HARTING Product Change Notification

PCN/21/032/C+N

Title: preLink M12 PushPull adaptation acc

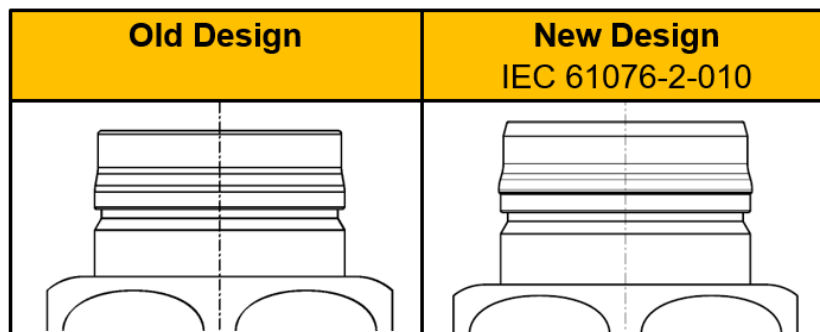
as part of our strategy to harmonize the M12 series according to the new international M12 PushPull locking standard IEC 61076-2-010, the contour of the preLink cable jack will be adapted according to the new standard. In this way, we offer our customers the advantage and security of being able to implement their cabling according to the international IEC 61076-2-010 standard.

The adaptation requires the implementation of so-called Double-PushPull-Contour at the flange of female device connector. This Double-PushPull-Contour ensures mating compatibility with our and 3rd party products which are in line with IEC 61076-2-010 standard. The following picture shows the adjustment.

Please note, that the Double-PushPull-Contour is **mating incompatible with our old PushPull cable connector**. Of course, you can still use standard M12 screwing in combination with the old and new PushPull contour. The following picture illustrates this.

This modification includes only changes of the PushPull locking contour without any effect on other elements of the connector (overall dimensions, shape, technical specification or assembly).
